Technical BULLETIN

2007 PZ50W/FXW/GTW/MW/VTW

Hard Starting in Extreme Cold Temperatures

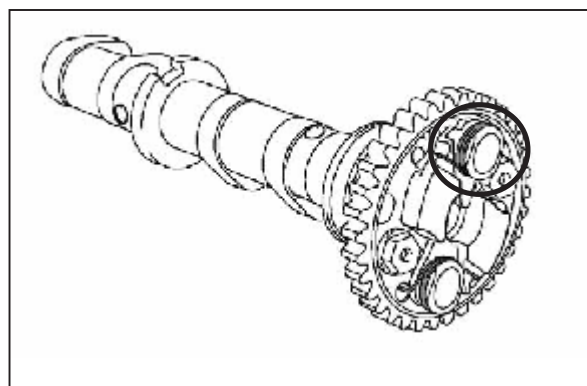
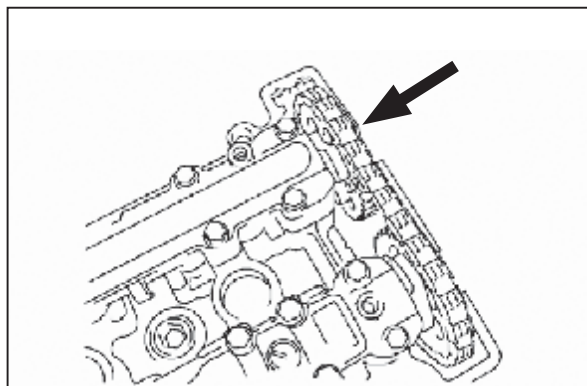
1. Remove the seat, fuel tank and any other parts (side panels, tank cover, and spark plug caps) to access the engine cylinder head cover.
2. Disconnect the negative (-) cable from the battery.
3. Remove the cylinder head cover.
4. Position the camshaft, by using the primary clutch to turn the engine in the normal direction of rotation (clockwise), to access the exhaust decompression spring.

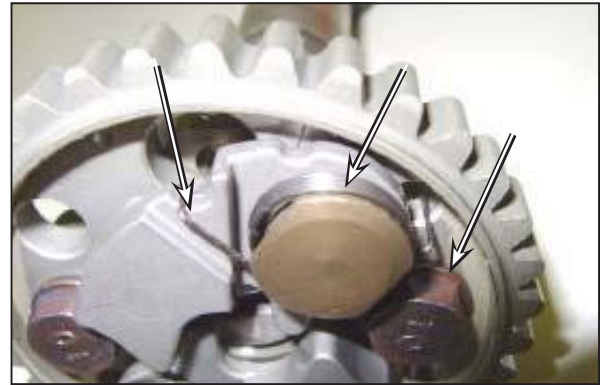
6. Remove the decompression spring as shown in the adjacent photo. Take care not to drop the spring into the engine.

7. Install the new decompression spring.

NOTE: Check that the spring is properly installed as shown in the adjacent photo.

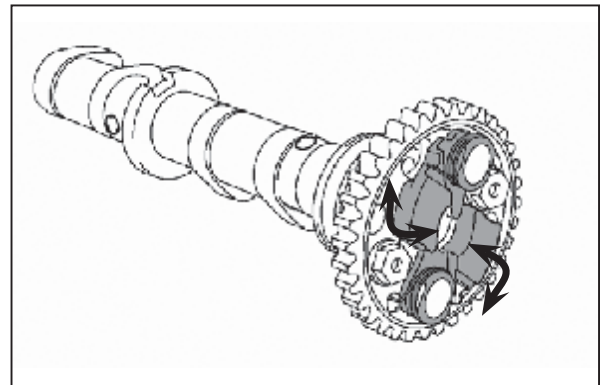
8. Using the primary clutch, turn the engine in the normal (clockwise) direction of rotation to access the other spring. Install the second spring.

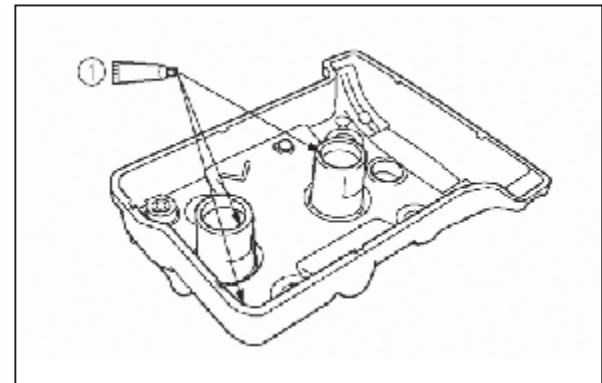
10. Re-install the cylinder head cover using the new gasket supplied in the kit.

Apply Yamabond 4 Motorsports to the cover ① surface and the mating surfaces of the cylinder head gasket and cylinder head ②.

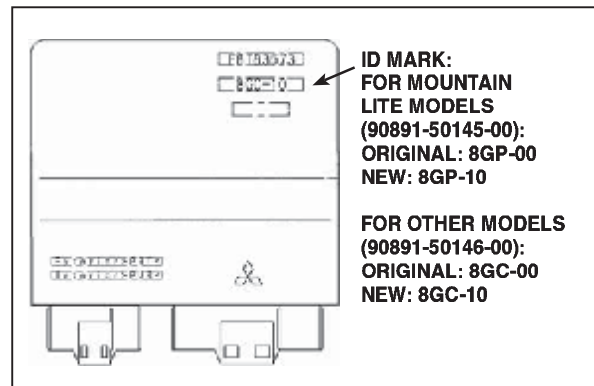
If you encounter an unfamiliar unit and you are unsure if the unit has been modified, check the ECU (see adjacent illustration).
